Memorandum

Re: Summary of hydrologic analyses on Twin Pines Mineral's (TP's) Charlton County project

With this letter I am presenting review comments of the report Impact of the Proposed Twin Pines Mine on the Trail Ridge Hydrologic System. The report was prepared by TTL of Tuscaloosa, Alabama, for Twin Pines Minerals, LLC. Several of the documents cited in the review were available from the wetlands/401/unit electronic files made available for the review. Each of the following comments is numbered and refers to a page in Impact of the Proposed Twin Pines Mine on the Trail Ridge Hydrologic System report.

Hydraulic Head Layer 1 July

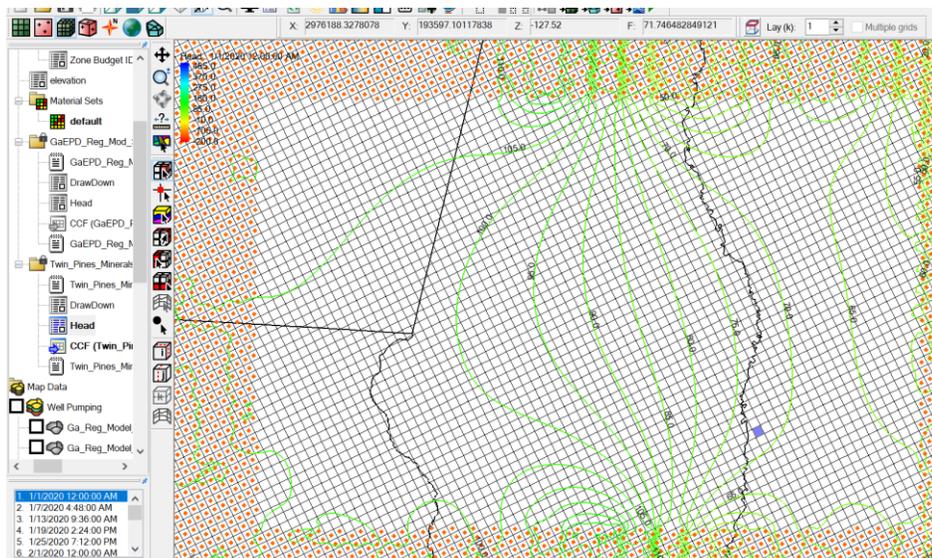
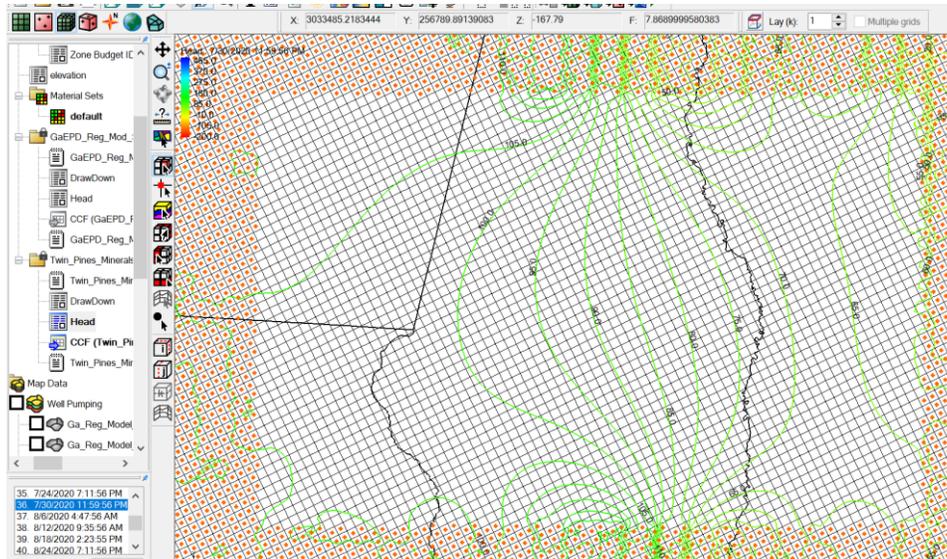
Comment 1 P. 3: It is stated in the report that MODFLOW-2005 was used to simulate steady-state groundwater flow in the model domain. Attached are figures from the State Water Plan revised transient model with Layer 1 in the vicinity of the proposed mine set to a variable head boundary.

The January hydraulic heads (period of high recharge and little agricultural pumping) looks the same as the July hydraulic heads (period of low recharge and much agricultural pumping). The lack of change in hydraulic heads between January and July indicates that a steady state model could be used to simulate conditions at the mine.

Figure 1. Flow exceedance at USGS 02231000

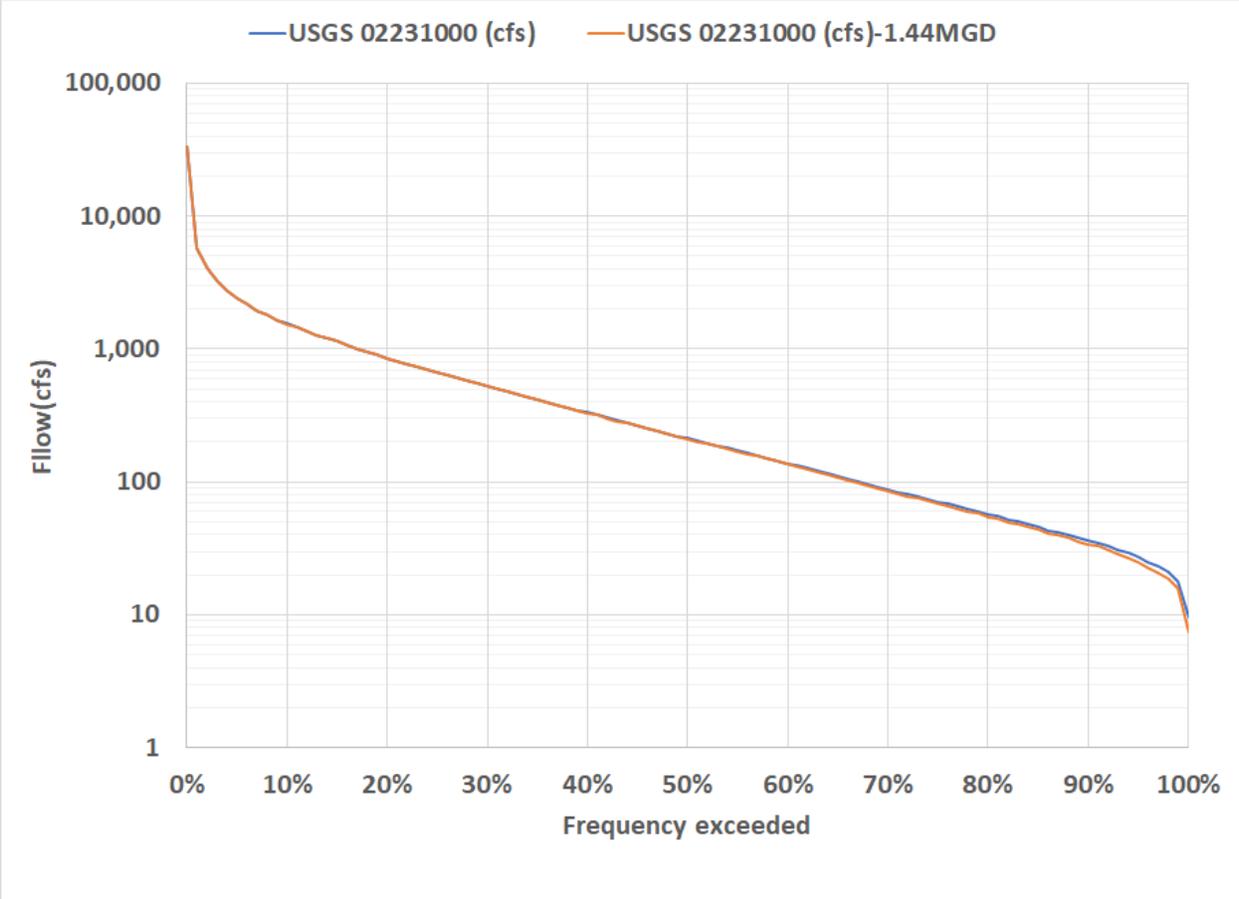
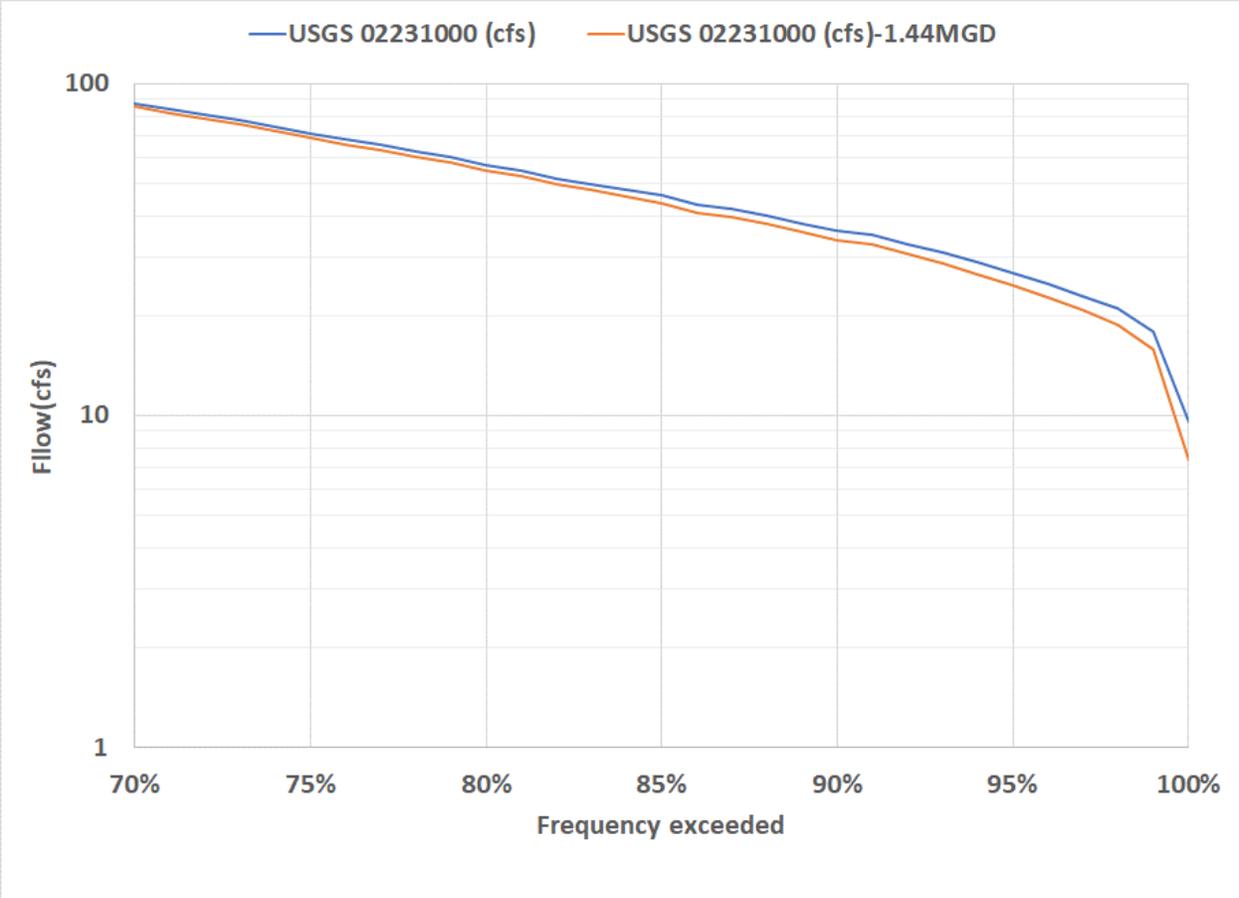
In order to make our point and maintain conservative, we continue to use the 1.44 mgd (2.23 cfs) as if it is entirely removed from the St. Marys River. Flow exceedance curves have been developed for the original gage record and an altered flow sequence as if 2.23 cfs has been removed from the original flow sequence. The two curves are very close for the upper 80% of the flow spectrum (Figure 1). We developed Figure 2 to zoom in to the lowest 30% of the flow exceedance. Here, we see the separation of the two curves, but the difference remains small. At the very low end of the flow exceedance curves, there may be an increase in the occurrence of such low flows (e.g. around 10 cfs). However, that is true when analyzing any magnitude of a flow reduction and on any stream.

Figure 3. Comparison of quality of USGS field measurements, 1954-1955

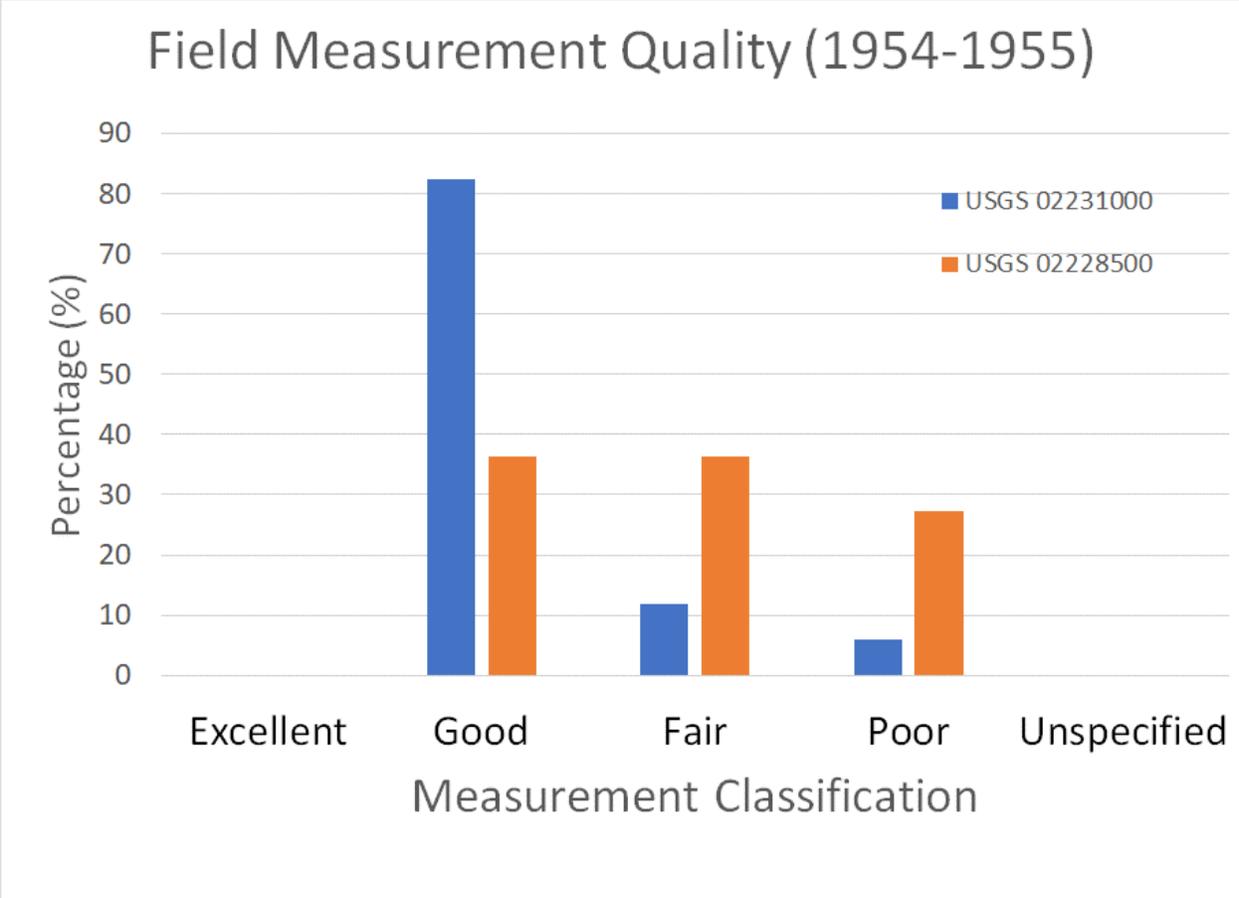
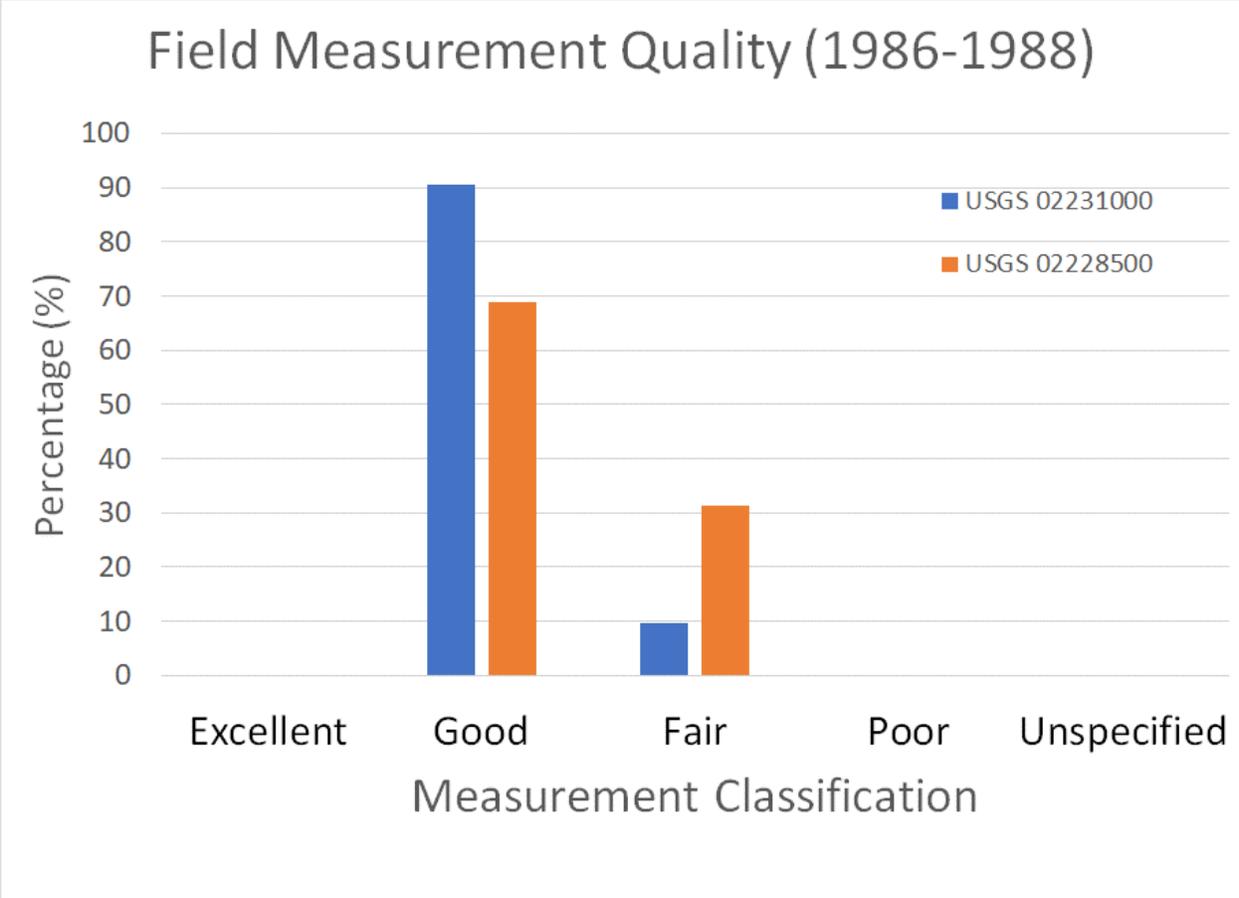
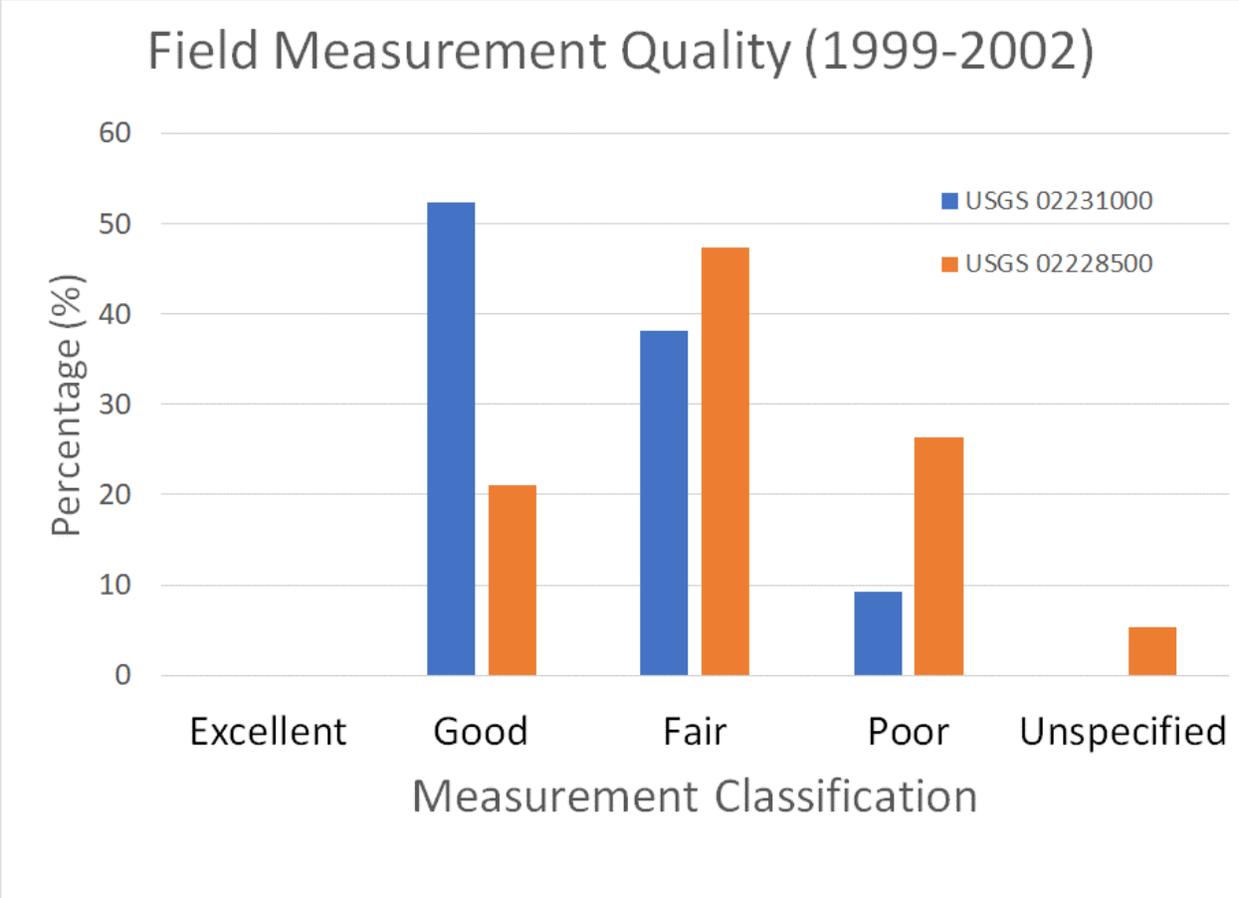
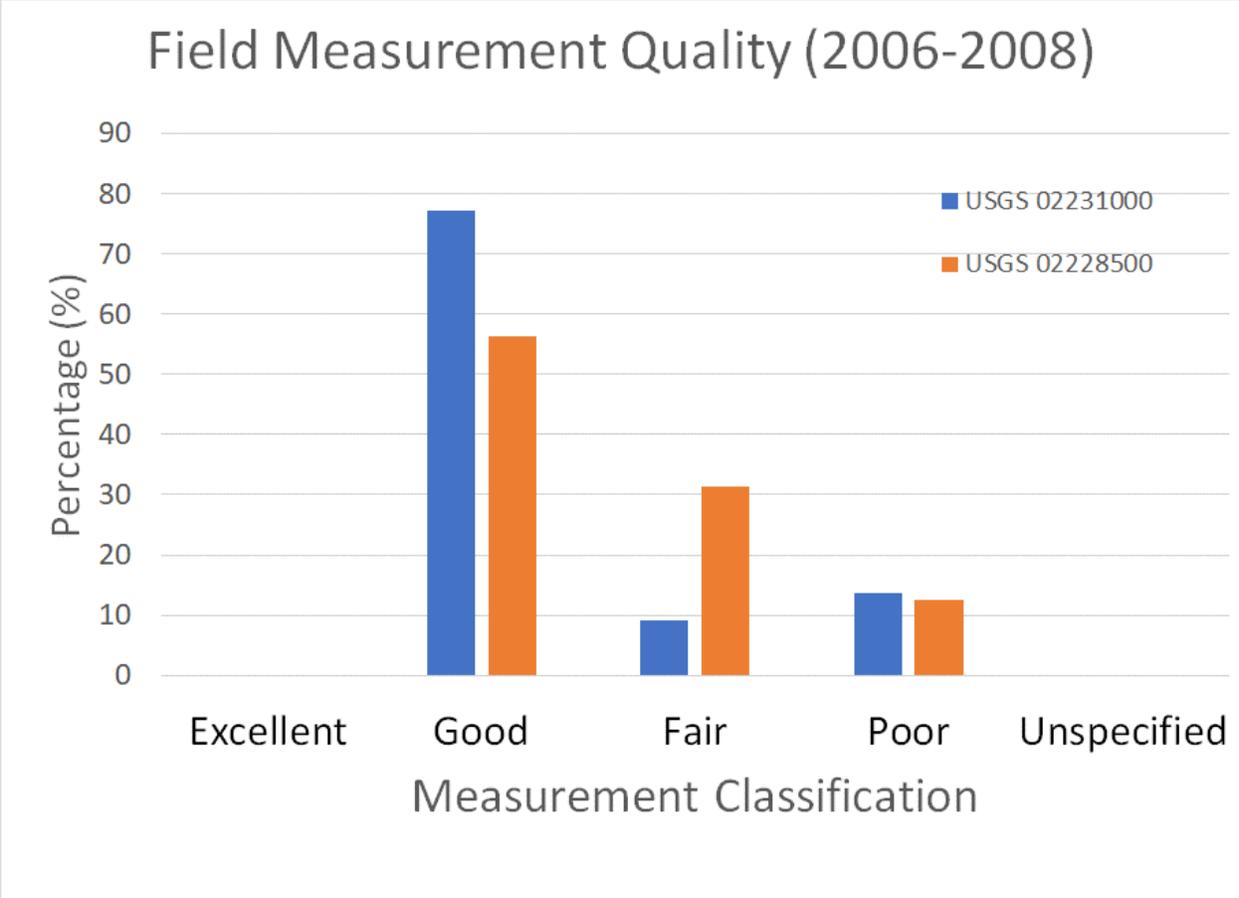
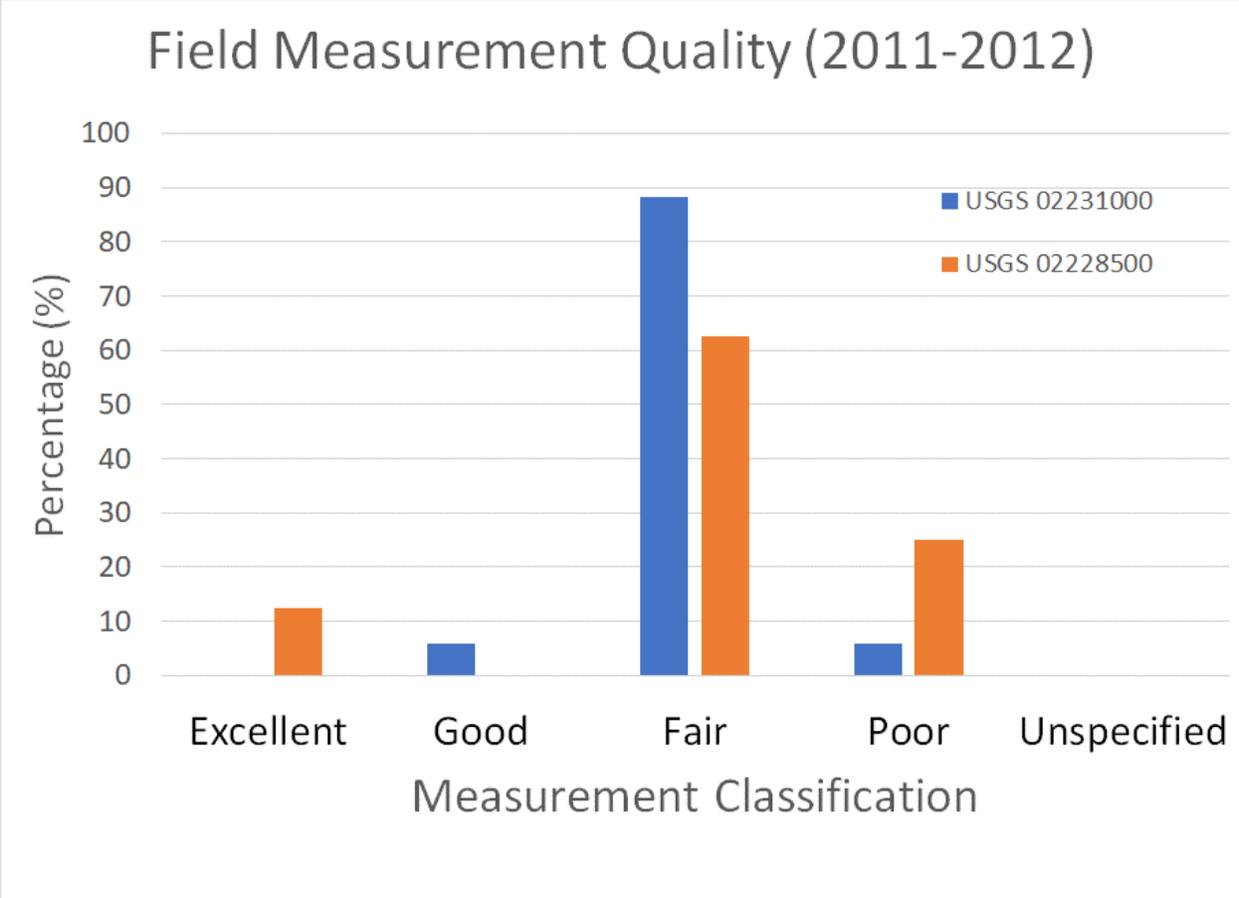
We developed Figures 3 through 7 to show the comparison of field measurement quality between the two gages. Figure 3 shows the comparison for the drought period of 1954-1955. Bars in the chart show the percentage of field measurement in each classification. The blue bars represent USGS 02231000, and the orange bars represent USGS 02228500. The percentage values associated with the bars of the same color add up to 100%. The higher the bars toward the left of the chart, the better the field measurement quality. The higher the bars toward the right of the chart, the poorer the quality of the field measurements. For example, during the 1954-1955 drought, USGS 02231000 has 82% of the field measurements classified as Good, while USGS 02228500 has 36% of its measurements classified as such. At the right side of the chart, USGS 02231000 has only 6% of the field measurements classified as Poor, while USGS 02228500 has 27% of the field measurements in that category.

Figure 4 shows a similar comparison for the drought period of 1986-1988. Figures 5, 6, and 7 are for the drought periods of 1999-2002, 2006-2008, and 2011-2012, respectively. It is almost universally true that USGS 02231000 provides higher bars on the left side of the charts, meaning higher quality field measurements, than USGS 02228500 does. The only exception in these figures is probably in Figure 7 showing the 2011-2012 drought, where USGS 02228500 has 12.5% of the field measurements assessed to be Excellent and USGS 02231000 does not have field measurements assessed in that category. But even for this multi-year drought, USGS 02231000 still has a lower percentage of Poor rating (at roughly 6%) than USGS 02228500 does (at 25%).

When the focus of a hydrologic analysis is on the lower end of the flow spectrum, especially when it is mostly about the extremely low flows, it is important to rely on gage data of better quality. We believe USGS 02231000 provides a longer period of record, a more complete record, and a record of higher quality in the historically critical drought years. We believe the use of this USGS gage is appropriate. Based on this data set and with very conservative assumptions, we believe the hydrologic impact on the St. Marys River from dewatering of the mining pit would be very low.
